2017-18 Transmission Planning Process – Draft Plan Comments

Submitted by	Company	Date Submitted
Matt Lecar 415-973-7743 Matt.Lecar@pge.com	Pacific Gas and Electric Company	February 23, 2018

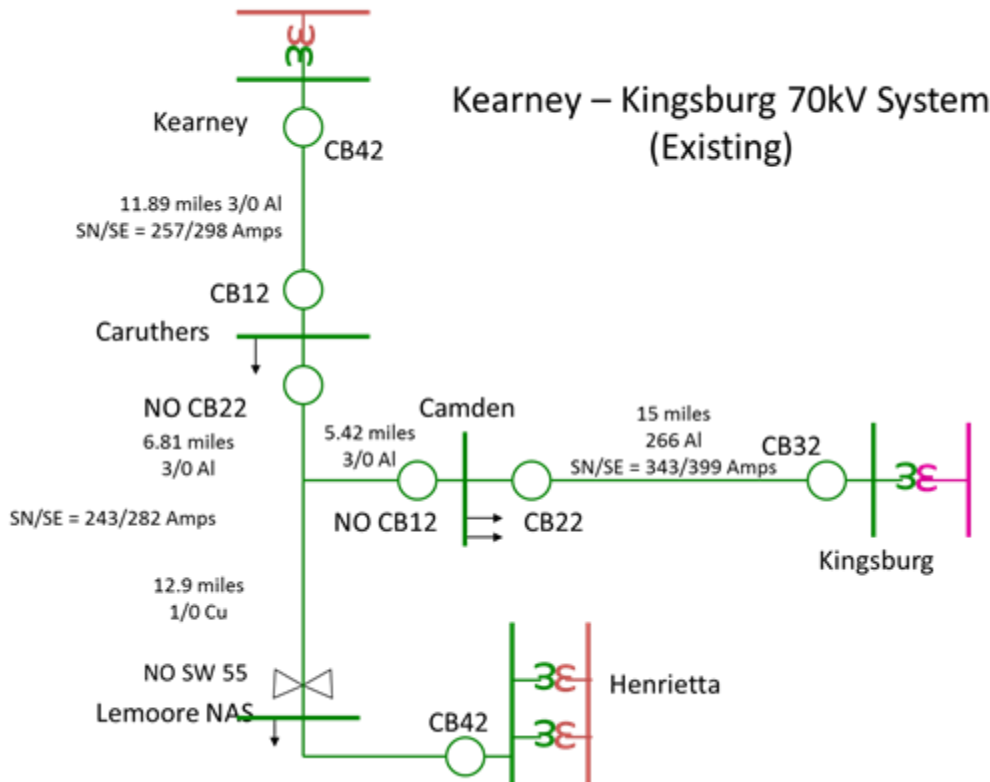
Oro Loma 70 kV Area Reinforcement -- It appears there is an error on the "current estimated cost" for original scope in the Draft Plan. PG&E requests that CAISO please update the estimate to \$167M. In addition, due to the potential need for permits/agency approvals, PG&E expects an in-service date of 2024.
